TOWN OF ACTON
472 Main Street
Acton, Massachusetts, 01720
Telephone (978) 929-6630
Fax (978) 929-6340

INTERDEPARTMENTAL COMMUNICATION

Subject: Site Plan Special Permit #07/03/14 - #451 – Acton Management Inc – 267 Great Road

We have reviewed the plans titled “Site Plan for Acton Management, Inc, 267 Great Road, Acton, Massachusetts” dated June 27, 2014 for the above mentioned special permit and have the following comments:

Acton Ladder Truck
 Width : 8.00 feet
 Track : 7.46
 Lock to Lock Time : 6.00
 Steering Angle : 45.0

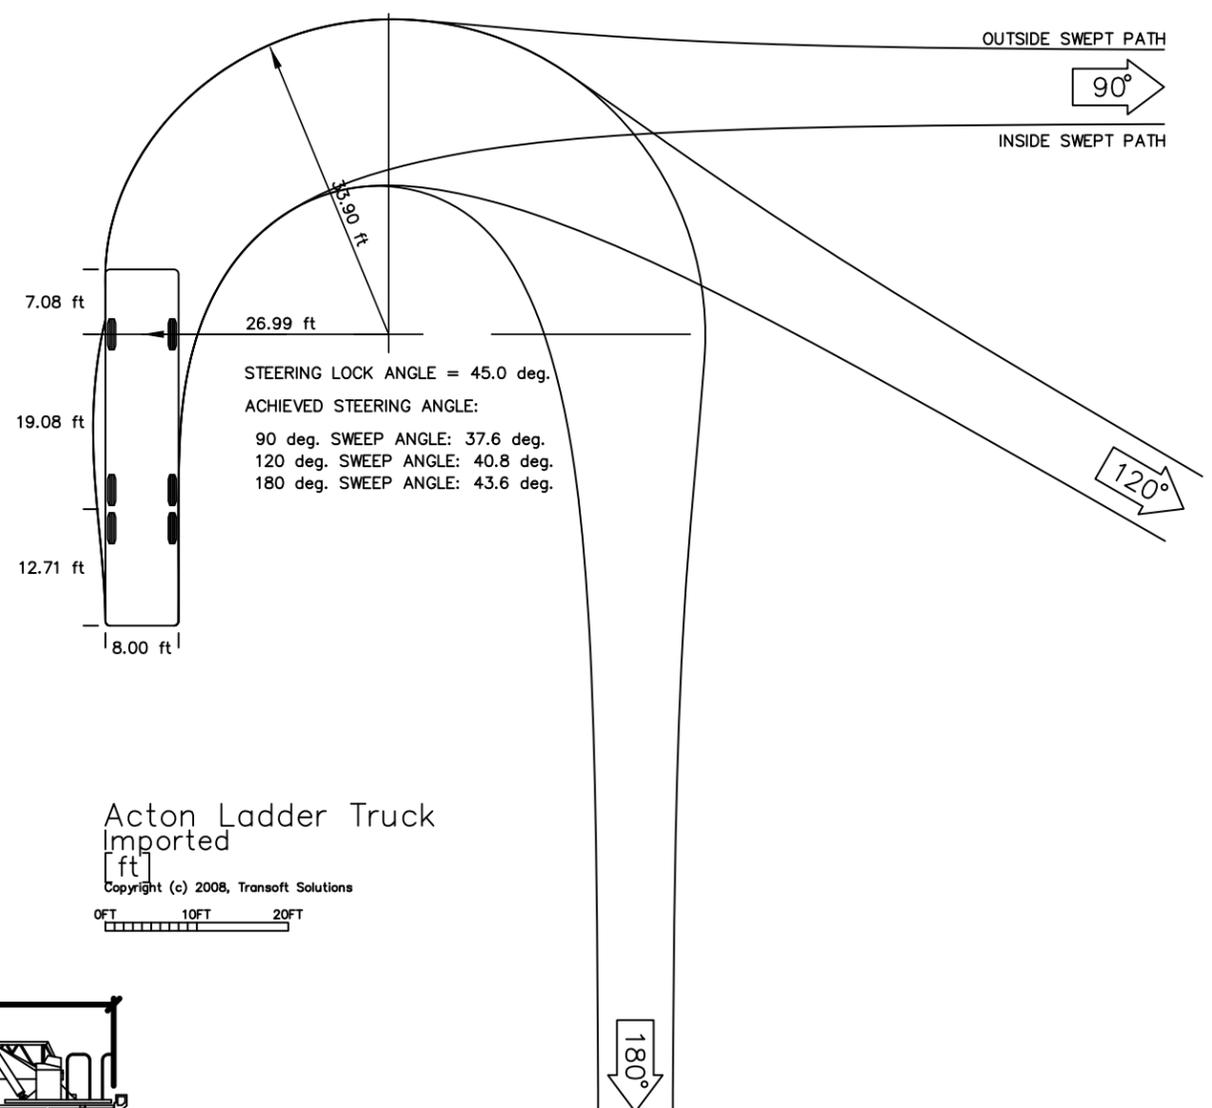
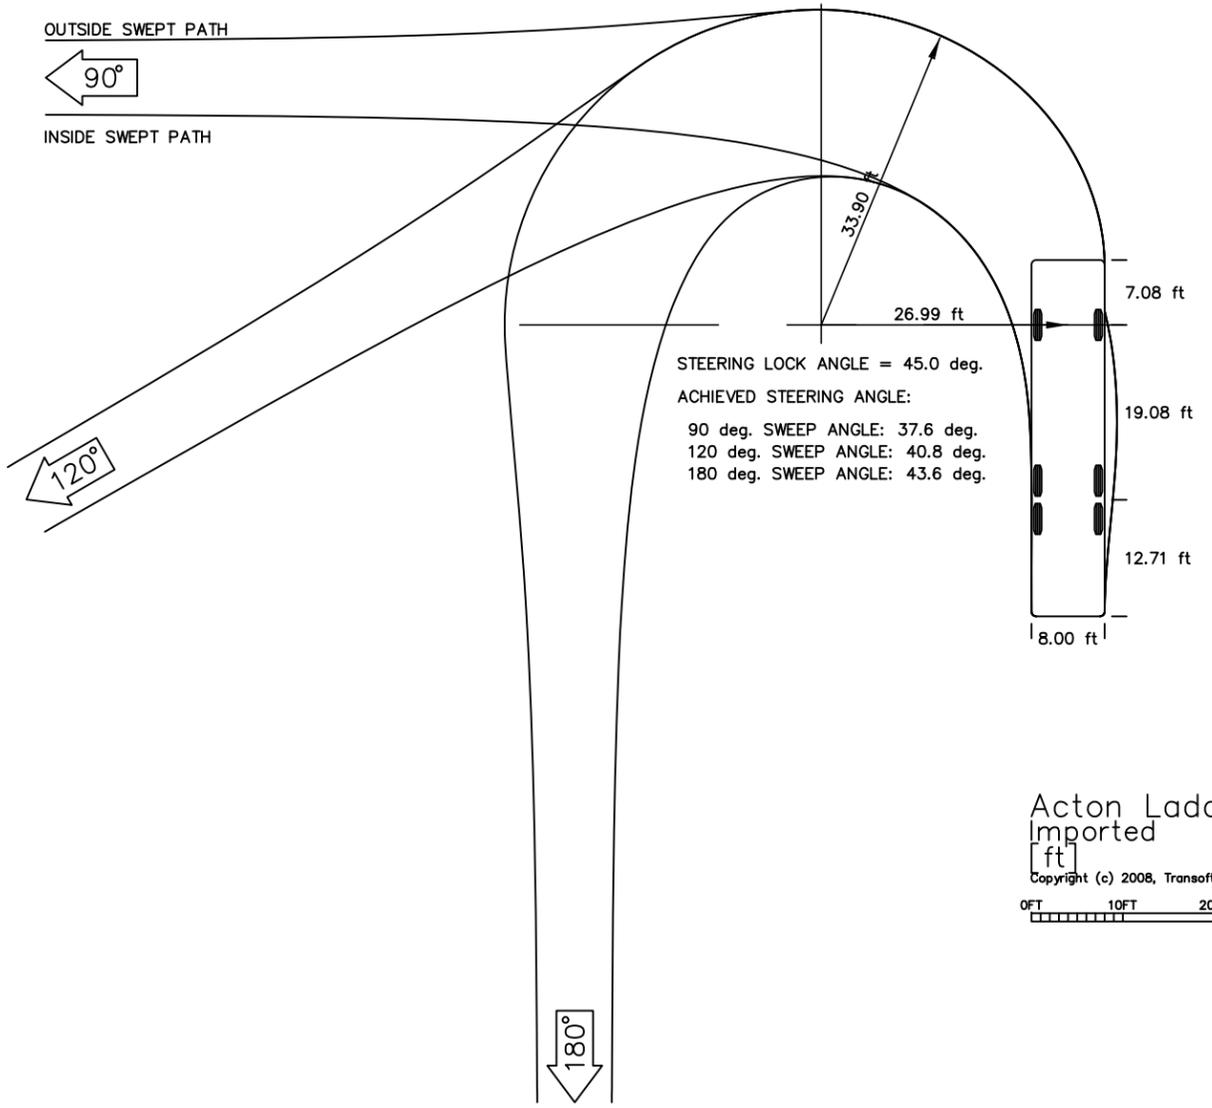
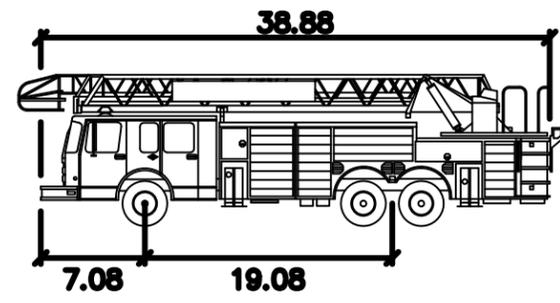
5. We request a copy of the MassDOT permit for the work shown within the road layout of Great Road for our records.
6. Based on our turning templates, an emergency SU-30 vehicle (fire truck) can maneuver within the site. Recently on another development the Fire Department has commented that the Acton ladder trucks are a different size than the SU-30 vehicle. Our office was given a copy of the ladder truck template by the applicant of the other development and we will supply that template with this memo. It appears the ladder truck would be able to maneuver within the parking area. We will defer further comment to the Fire Department.
